UNITED STATES PATENT AND TRADEMARK OFFICE

APPLICATION NO.	FILING DATE	FIRST NAMED INVENTOR	ATTORNEY DOCKET NO.	CONFIRMATION NO.
10/753,094	01/07/2004	Robert K. Kopras	035568-0122	2746

Office Action Summary

Title: ATTACHMENT FOR POWER TOOL

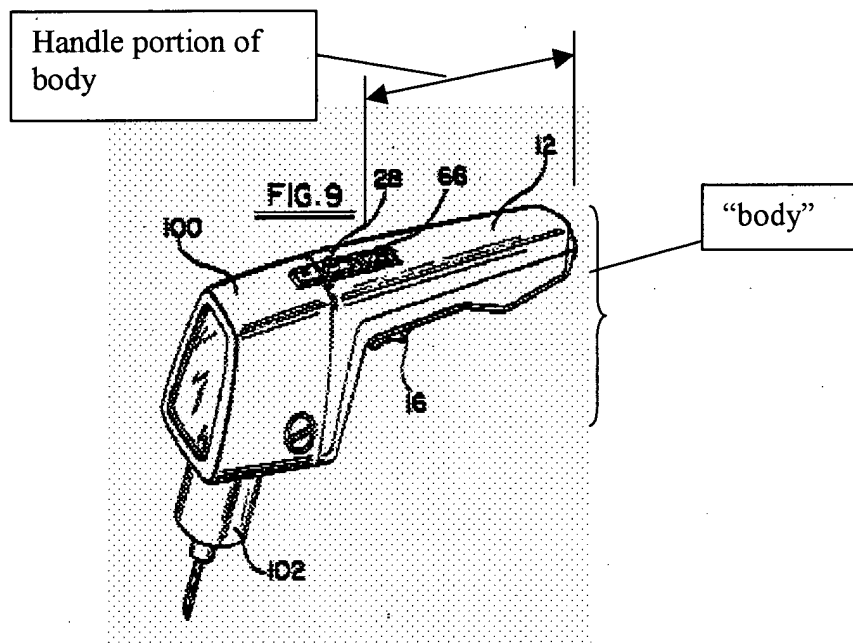
Owings teaches an attachment device including a “body” having a “handle” portion (labeled in the reproduction of Figure 9 below), which attachment is selectively attachable to a rotary cutting tool (for example, see Figures 9 and 13). Note specifically that the handle in

Figure 9 has at least a portion extending generally perpendicularly to a central longitudinal axis of the rotary cutting tool (see Figure 9).

Re the handle being of a “size sufficient to accommodate an entire palm of a power tool user”, as best understood, it is noted that the upper surface (as viewed in Figure 9) of the “handle” portion would appear to be large enough to support the entire palm of a user of the power tool (see Figure 9).

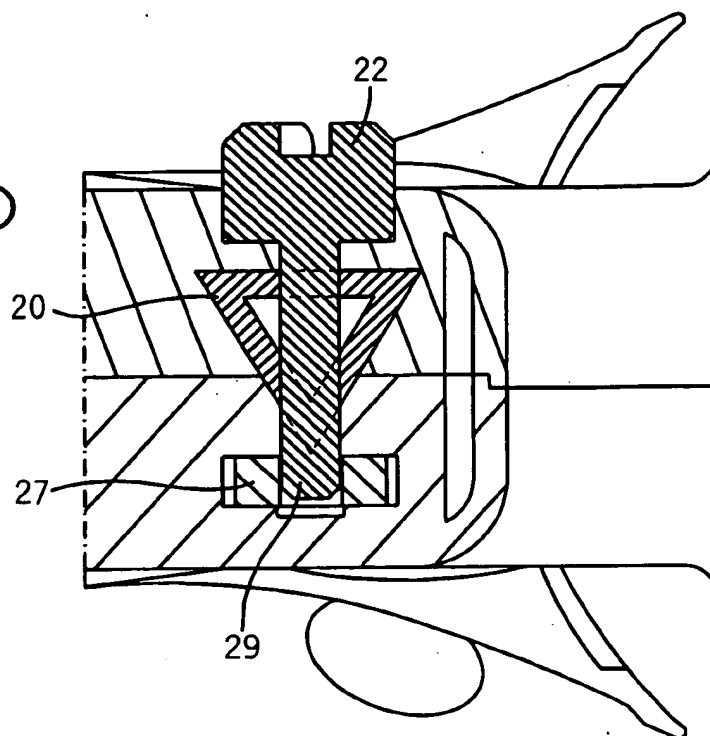
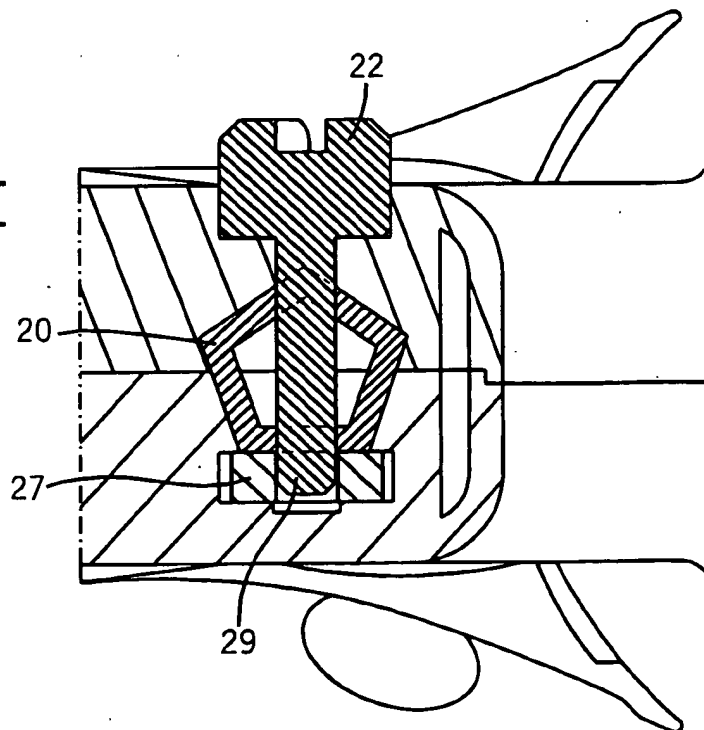
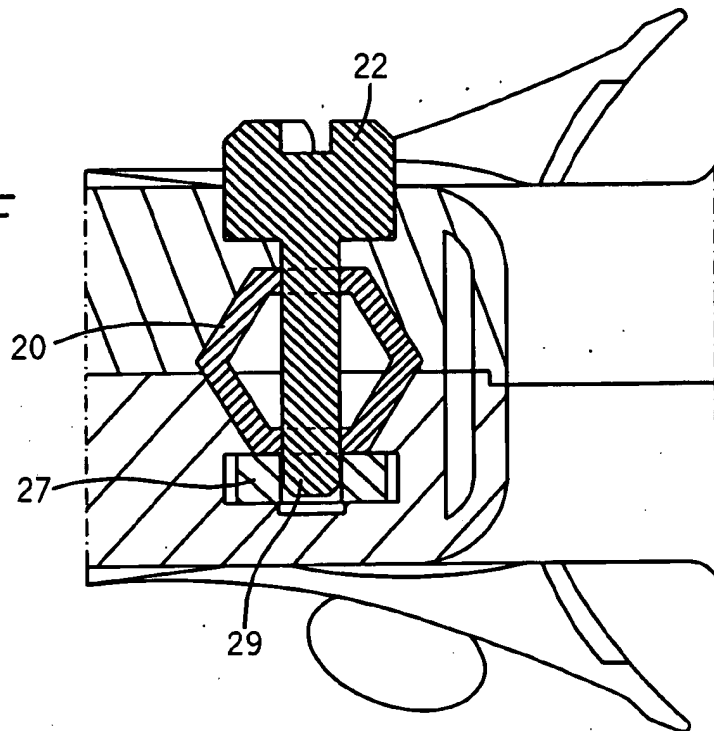
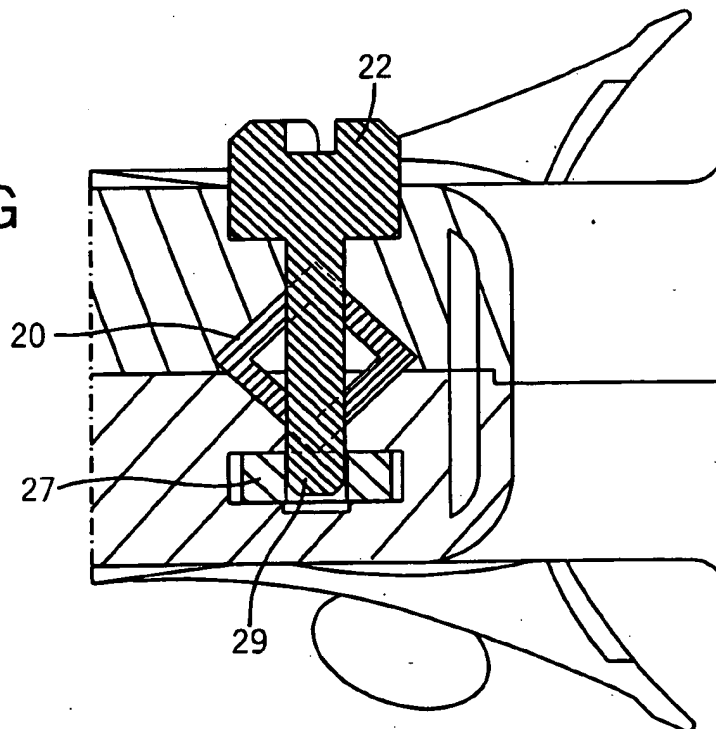
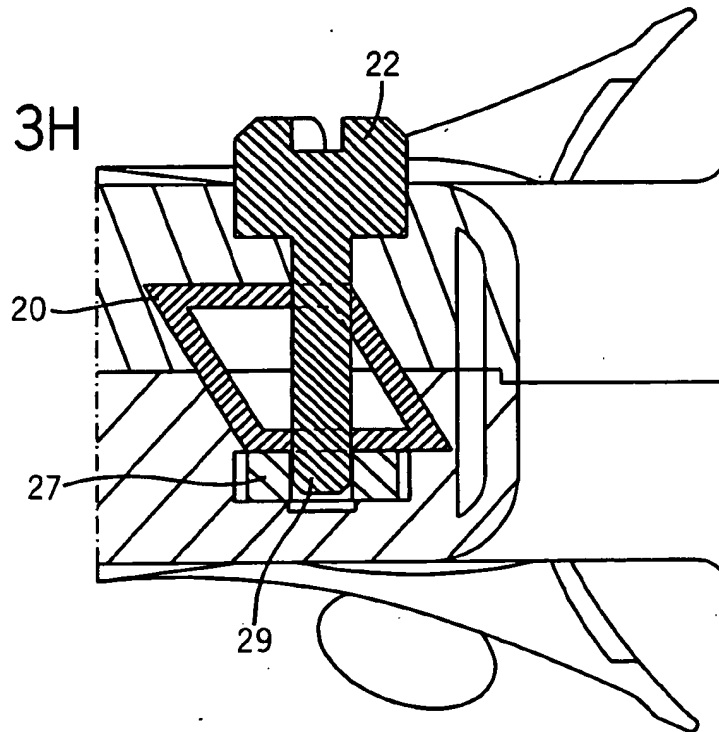
3. The amendment filed February 27, 2006 is objected to under 35 U.S.C. 132(a) because it introduces new matter into the disclosure. 35 U.S.C. 132(a) states that no amendment shall introduce new matter into the disclosure of the invention. The added material which is not supported by the original disclosure is as follows: The proposed Figures 3D through 3I are not approved because, even though the original specification does teach that the shaft can have a cross-sectional shape of a "triangle, a pentagon, a hexagon, a diamond, a rhombus, an octagon..." (at least paragraph 0051), the specification does not provide for the level of detail shown in the new Figures 3D through 3I. For example, the specification does not teach whether the triangle is a right triangle, an isosceles triangle, a scalene triangle, an equilateral triangle, etc., and specifically does not teach that the triangle is a triangle having the shape shown in Figure 3D, nor that the triangular cross section is configured or located as shown in Figure 3D such that it is intersected by the thumbscrew 22 at the locations of the triangle that are shown in Figure

3D. With regard to the other shapes claimed, similarly, the specification as originally filed does not teach any details of the polygonal shape beyond the “pentagon, hexagon, diamond, rhombus, or octagon” description, and thus doesn’t teach, with respect to the pentagon, hexagon, diamond, or octagon, whether the sides are of the same length or not, nor does the specification teach how these shapes are positioned or configured with respect to the device such that it is known where they are intersected by the thumbscrew 22. Furthermore, the specification does not appear to teach that the cross-section of each of these shaft shapes is a hollow cross section as is shown in new Figures 3D through 3I.

4. The drawings are objected to under 37 CFR 1.83(a). The drawings must show every feature of the invention specified in the claims. Therefore, the shaft having a cross-sectional shape that is selected from a “triangle, a pentagon, a hexagon, a diamond, a rhombus, and an octagon” of claim 8 must be shown or the feature(s) canceled from the claim(s). No new matter should be entered.

5. The amendment filed February 27, 2006 is objected to under 35 U.S.C. 132(a) because it introduces new matter into the disclosure. 35 U.S.C. 132(a) states that no amendment shall introduce new matter into the disclosure of the invention. The added material which is not supported by the original disclosure is as follows: the addition to paragraph 0051 that refers to the new figures 3D-3I, which, as described above, contain new matter; the new paragraphs 0019A through 0019F, which refer to the new figures 3D-3I, which, as described above, contain new matter.

Not
Approved
5/24/06
GAC

Not
Approved
ccc 5/24/06

Not Approved
5/29/06
Gee

Applicant is required to cancel the new matter in the reply to this Office Action.

Applicant is required to cancel the new matter in the reply to this Office Action.
